ML071010213

Subject: UniStar Nuclear, NRC Project No. 746
Submittal of the Published UniStar Nuclear Topical Report No. UN-TR-06-001-A,
"Quality Assurance Program Description," Revision 0

**UniStar Nuclear Response to NRC Request for Additional Information Regarding
Proposed Revision 1 of the UniStar Nuclear Quality Assurance Program Description
Topical Report UN-TR-06-001**

Figure A-1

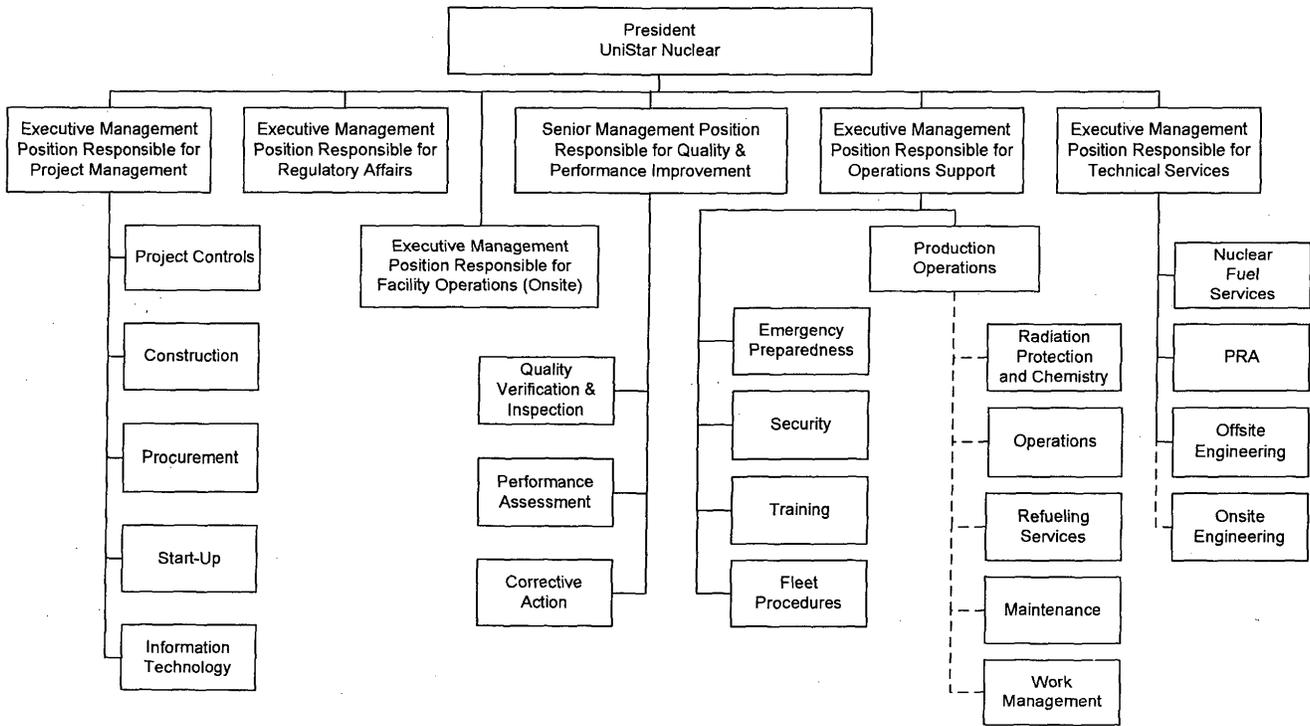
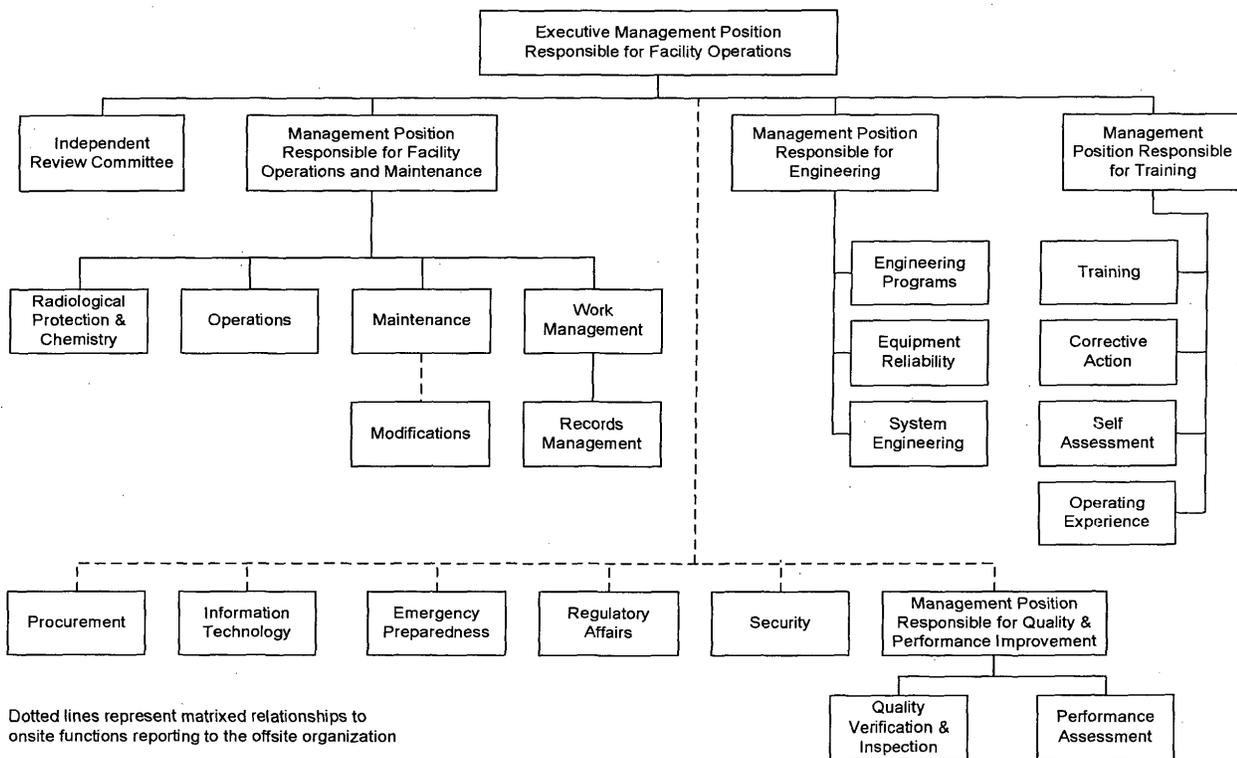
- c. The Operating Organization and Functions section: 1) does not state whether the Executive Management position responsible for Facility Operations and the Management Position responsible for Facility Operations and Maintenance are onsite or offsite; 2) does not have the same title descriptions for Training and Engineering as depicted in Figure 3; and 3) does not specify to which corporate management position (offsite) the site management position for training functionally reports.

- d. The QA Organization and Functions section: 1) does not state whether the management position, the QA organization, and the position added to the QA organization after transition to operations are onsite or offsite; 2) does not depict the QA organization on Figure 1; and 3) does not clearly indicate whether the position added to the QA organization after transition to operations is a management position.

1. Section A, including the organization charts, have been revised to better delineate the Offsite and Onsite organizations and reporting relationships.
2. Title descriptions have been corrected.
3. The position description and organizational charts have been revised.

1. Section A, including the organization charts, have been revised to better delineate the Offsite and Onsite organizations and reporting relationships.
2. The functional responsibilities of the Senior Management position responsible for Quality and Performance Improvement are provided in brief under the Corporate (Offsite) Organization and more fully under the Quality Assurance Organization.
- 3) The position is a management position. The description and organization chart has been revised to so indicate.
